Interactive comment on “The 2018 Lake Muir earthquake sequence, southwest Western Australia: rethinking Australian stable continental region earthquakes” by Dan J. Clark et al.

Reply to specific comments made by EC1:

Fig. 1. Revised Figure 3: Map of the Lake Muir surface ruptures and associated seismicity.

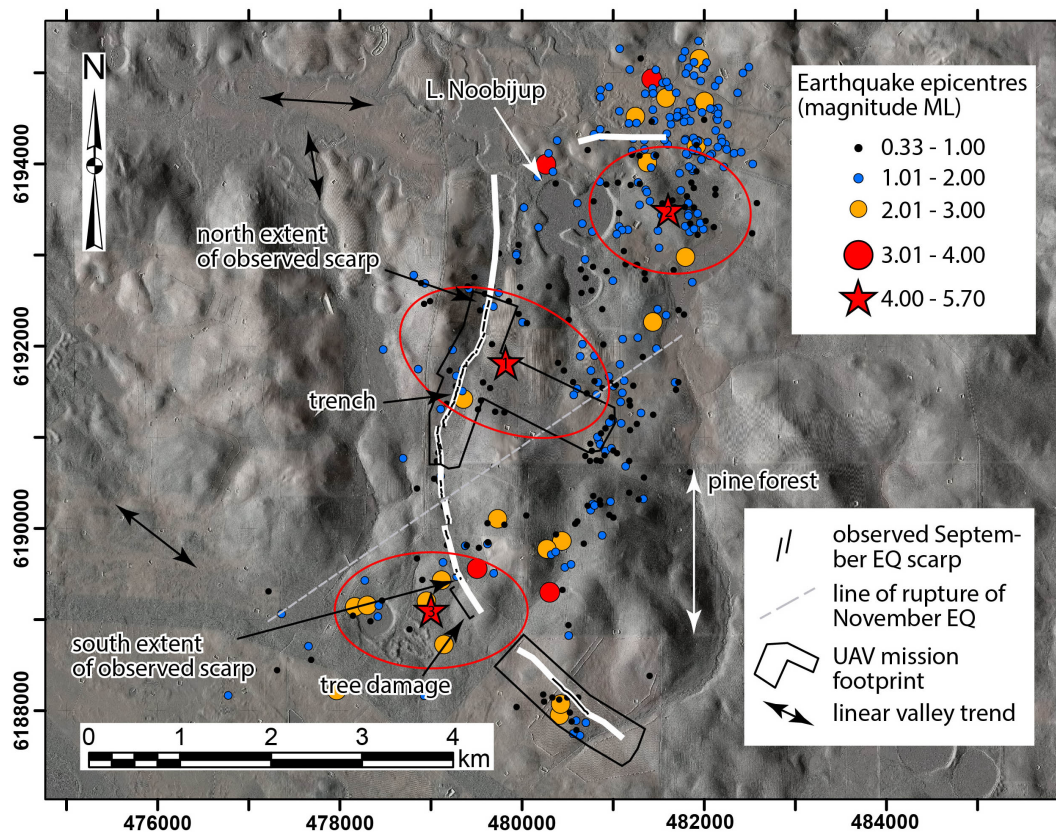
deductions on earthquake genesis and relationships to faulting may be made from our main shock locations and aftershock relocations. We recognise that the uncertainties relating to earthquake locations were not well-communicated, and have rectified this deficiency. Specifically, we note that the uncertainties on aftershock locations are better than 300 m in all cases. The reviewed manuscript presented the initial Australian National Seismic Network locations for the three largest events in the sequence as these events failed key tests for double-difference relocation. This resulted in the undesirable situation where the main shocks were associated with horizontal location uncertainties of 5-6 km. In the revised manuscript we have relocated the two largest events based upon the relatively well located third largest event in the sequence. This relocation has resulted in collapse of the horizontal location uncertainty ellipses to ~ 1 km, and allows for better comparison between main shocks, aftershocks, and surface and geological data. The revised Figures 3 and 6 are attached as an example of the improvement.
